The following HED  
Implementation  
Documents or  
Dispositions Have Been  
Modified  
See Addendum For  
Update

DAVIS-BESSE HUMAN ENGINEERING DISCREPANCY REPORT  
ADDENDUM

HED NO: 12001      DATE OF ORIGIN: 09/01/83      REVISION DATE: 06/08/88  
TITLE: CONTROLS NOT 3 INCHES AWAY FROM FRONT EDGE OF THE BENCHBOARD

JOB NO.	DRAWING NO.	REV. NO.
12501	904761 SH 505	81
VDCN NUMBER		
7749. M-340-6-10-B		
Vendor VICTOREEN

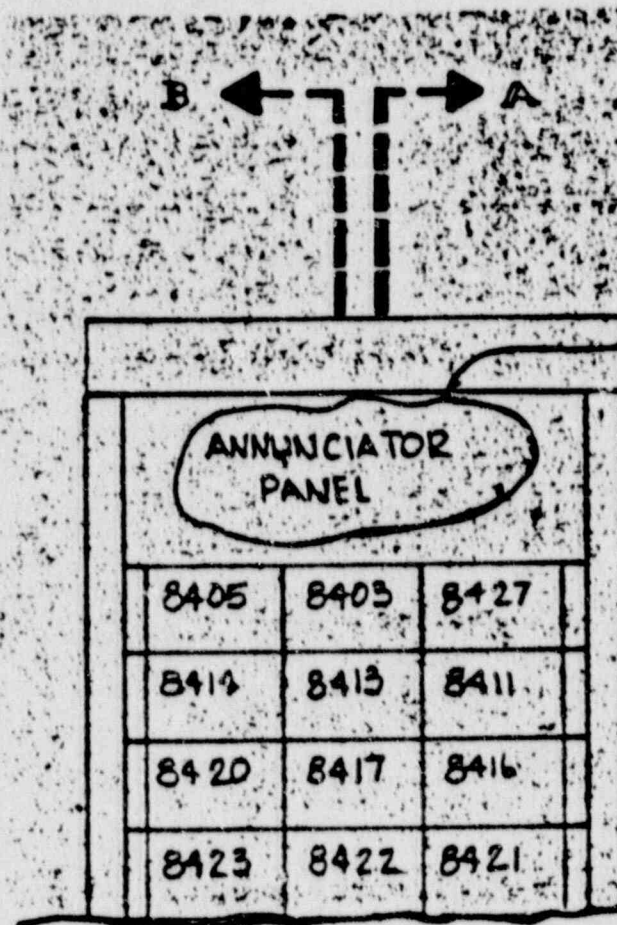
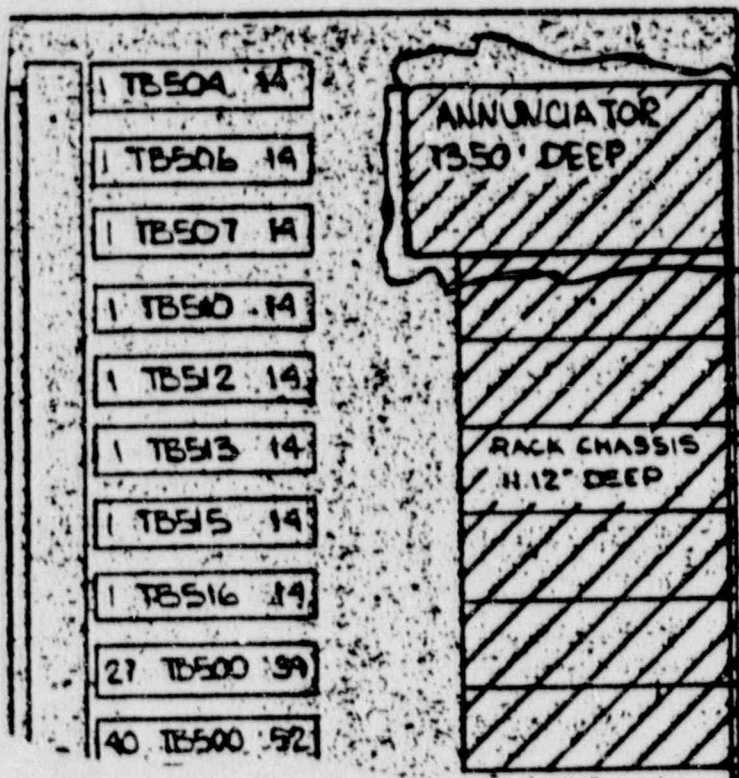
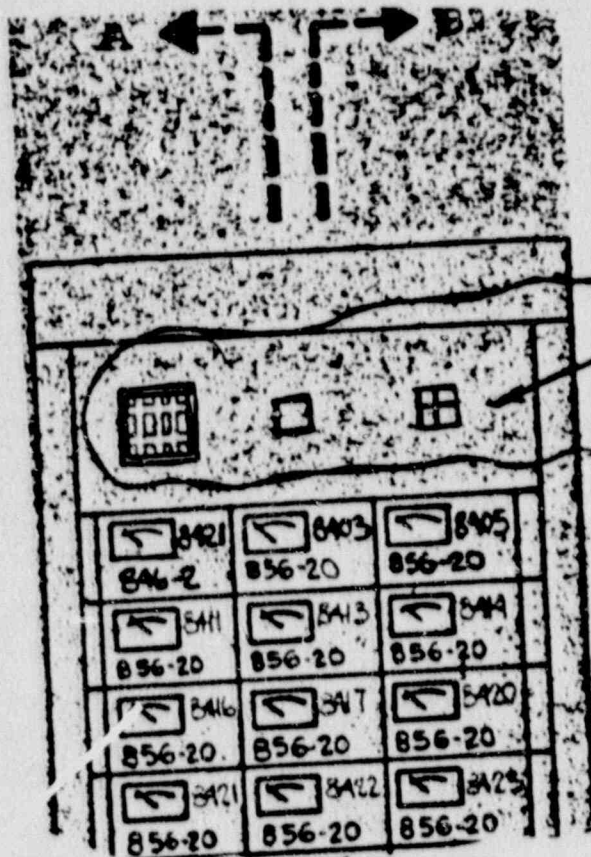
VDCN 7749-M340-6-10-B Page 1 of 3 deleted non-functional Annunciator Panel. Annunciator has been previously disconnected. The HED portion of the modification has been completed.

FCR 79-0322-12 VDCN 7749-M340-6-10 Page 1 of 3 deleted non-functional annunciator panel. Annunciator had been previously disconnected. HED portion of the modification has been completed.

Area of  
change  
TO BE REMOVED

JOB NO.	DRAWING NO.	REV. NO.
7749	904761 SH 9 OF 5	G
VDN NUMBER 7749-M-340-6-12-24		
CONTINUATION SHEET		
PAGE	2	OF 2

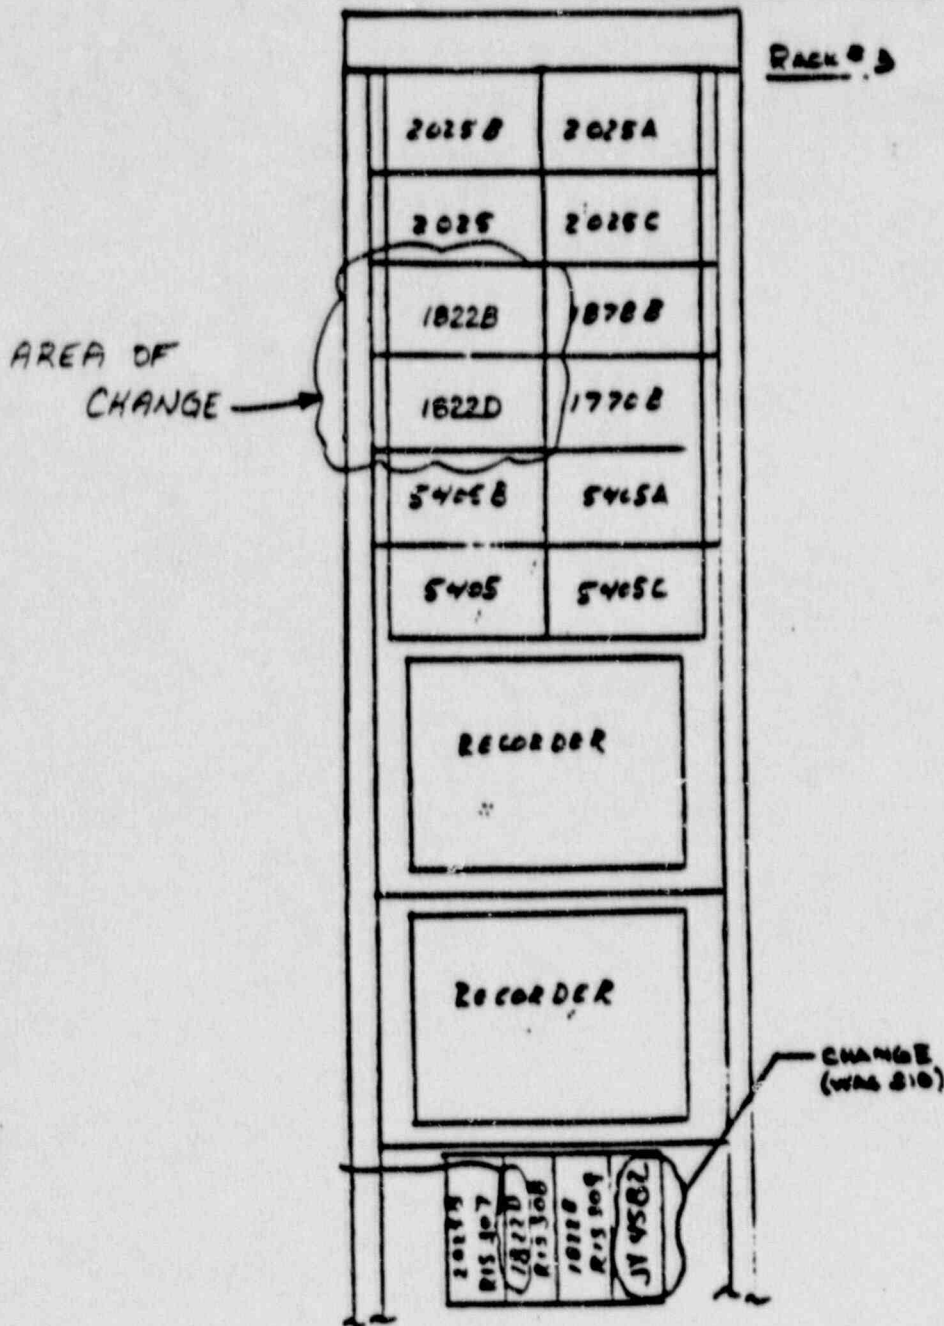
AREA OF CHANGE

JOB NO.	DRAWING NO.	REV. NO.
7749	904761 SH 10F5	B3
VDEN NUMBER		
7749-M-340-6-12-25		
Vendor VICTOREEN

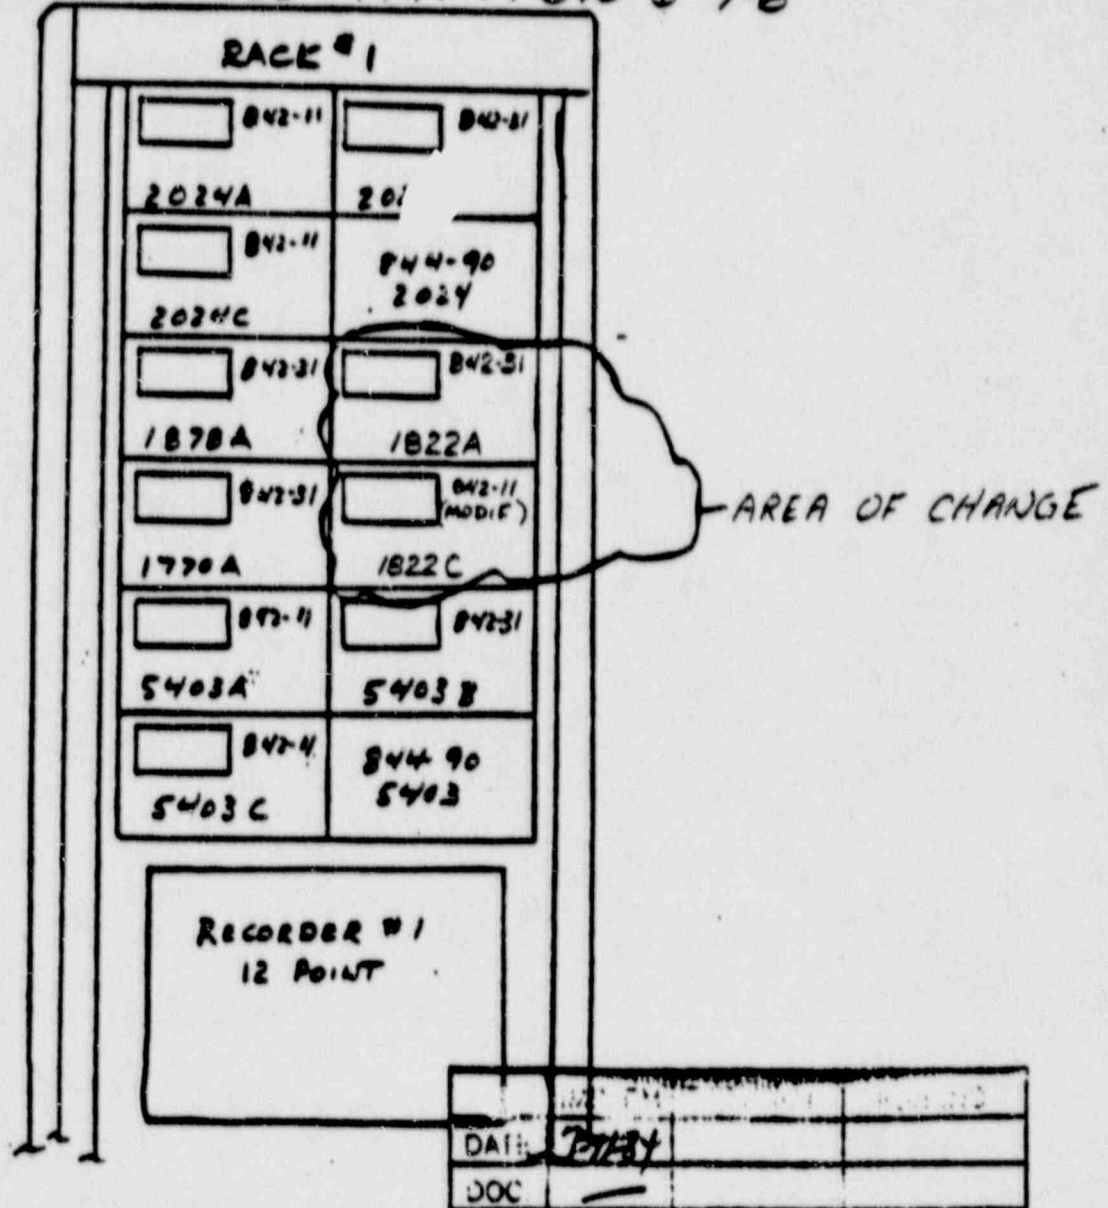
THIS VDCN SUPERSEDES VDCN 7749-M-340-6-9-6

CHANGE  
(WAS 609)

JOB NO.	DRAWING NO.	REV. NO.
7749	904546 SH 2054	B2
VDCN NUMBER		
7749-M-340-21-18-6		
Vendor VICTOREEN		
PAGE	1	OF 1

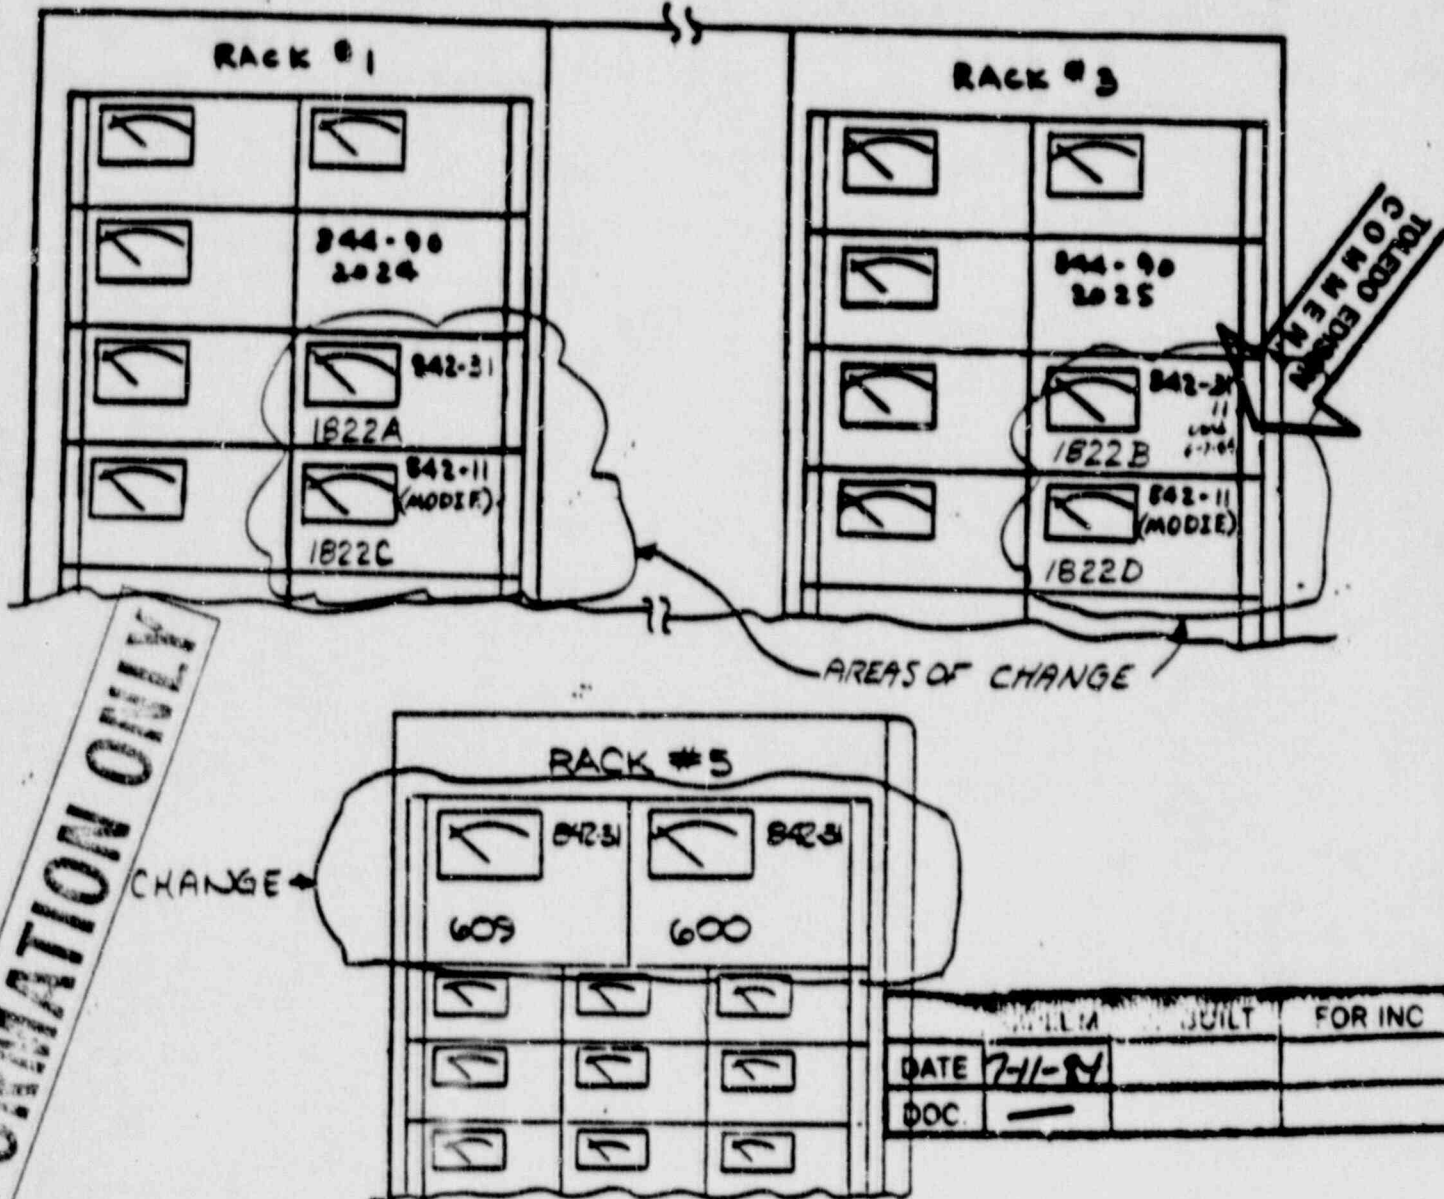
THIS VDCN SUPERSEDES VDCN 7749-M-340-21-16-3
